## Appendix A – RTS Matrix

Issue Raised	Response	RTS Appendix
<b>NSW Department of Planning, Housing and Infrastructure</b>		
<b>1. Rouse Hill Statutory and Strategic Considerations</b>		
<ul style="list-style-type: none"> <li>• Provide an assessment of the impacts from the proposed variation from the Level 1 Masterplan and Level 2 Precinct Plan, including but not limited to:               <ul style="list-style-type: none"> <li>– Justify the suitability of introducing residential land uses and reducing employment generating land uses on the site, particularly the increase in dwelling yield / density / height above what has been previously envisaged and approved under the Level 1 Rouse Hill Masterplan and Level 2 Precinct Plan.</li> </ul> </li> </ul>	<p><b>Level 1 Masterplan DA</b></p> <ul style="list-style-type: none"> <li>▪ The Level 1 Masterplan DA (1604/2004/HB) was approved by Baulkham Hills Shire Council (now Hills Shire) on 26 March 2004. The Level 1 Masterplan applies to the subject site and wider Rouse Hill Regional Centre.</li> <li>▪ The Level 1 Masterplan approved 200,000 sqm retail and commercial floor space and 1,800 dwellings, including residential apartments (515), t

Figure 63. Current and Future Active Open Space Areas

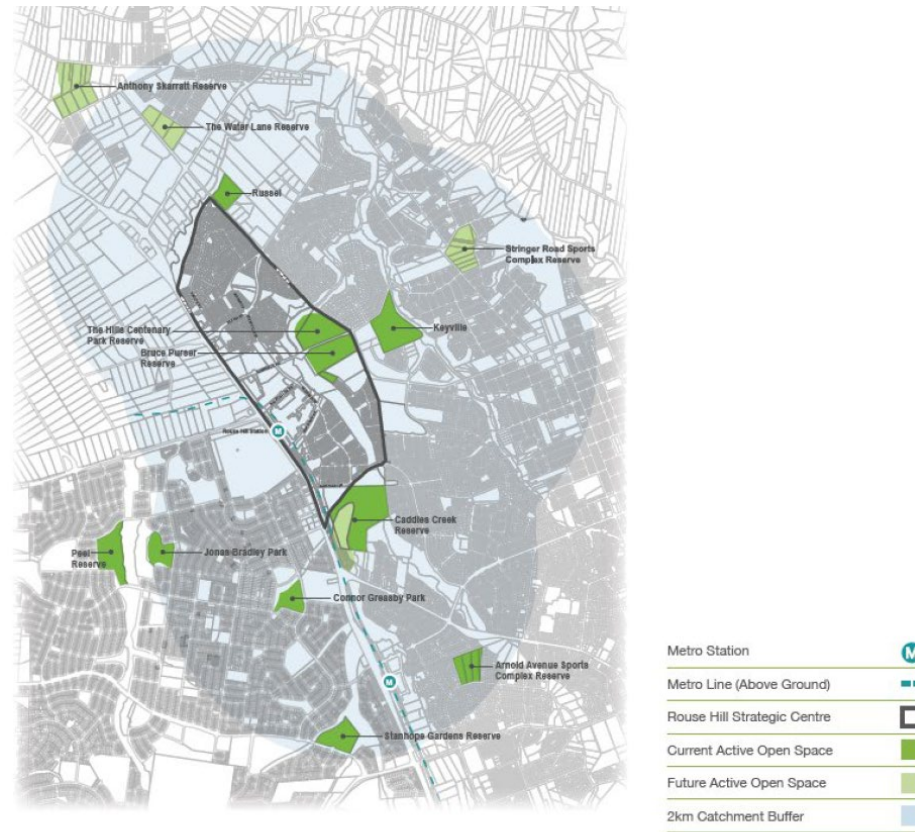
Issue Raised	Response	RTS Appendix
	<p><u>5. Open Space Provision – Active</u></p> <p>The Rouse Hill Precinct Plan (2023) assesses that the area is nearing capacity for active recreation facilities. The Precinct Plan states as follows:</p> <p><i>“There is only capacity to cater for an additional 500-1,000 dwellings within the Strategic Centre (beyond the growth already anticipated under the current controls) subject to further embellishments to increase capacity.”</i></p> <p>While not unlimited, figures of 500-1000 dwellings confirm that there is some capacity presently remaining. Under the provisions of Contribution Plan No. 8, there is also provision for contributions to be made by development towards open space provision, both capital and land.</p> <p>The recommendations of the Precinct Plan do not specifically alter the planning framework for the site. The ability to advance the development is not dependent on the precinct plan recommendations and implementation.</p>
